TVA Disposal Facility Assessment Phase 1 Plant Summary Paradise Fossil Plant (PAF)

TVA Disposal Facility Assessment
Phase 1 Coal Combustion Product Disposal
Facility Summary
Paradise Fossil Plant (PAF)
Scrubber Sludge Complex - Gypsum Stack (GS)

Drawing Mark GS-1

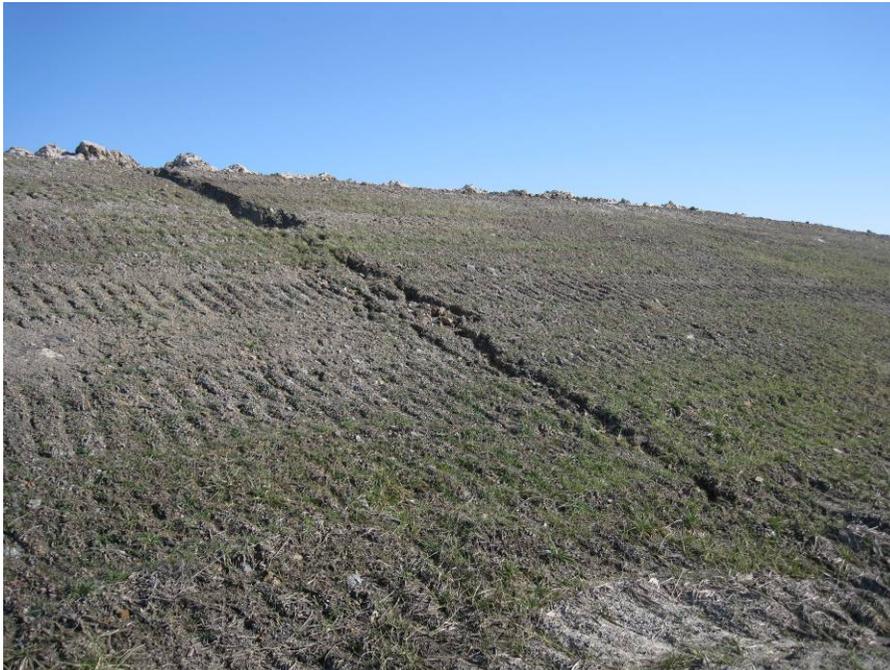
Minimal available freeboard along saddle dike and majority of west pond embankment.

Drawing Mark SM-2

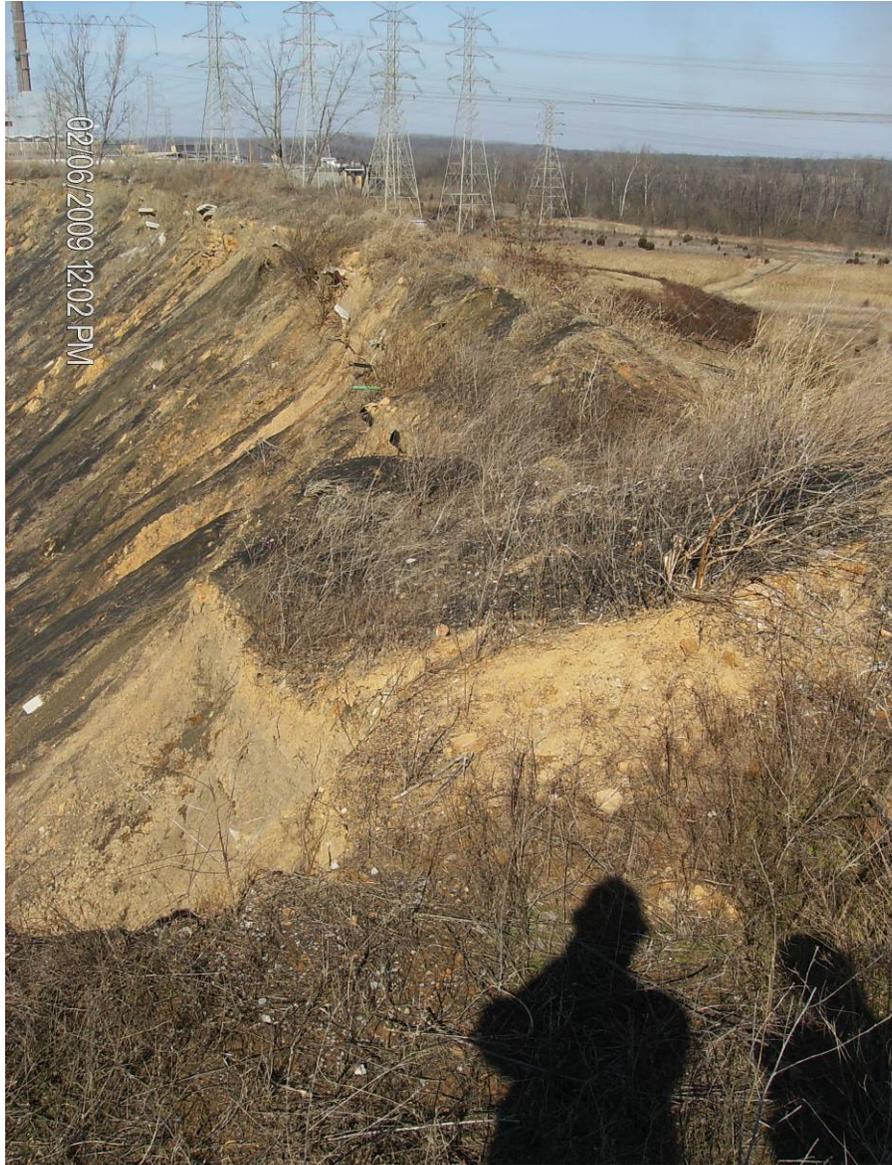
General conditions of coal ash staging/mining area.
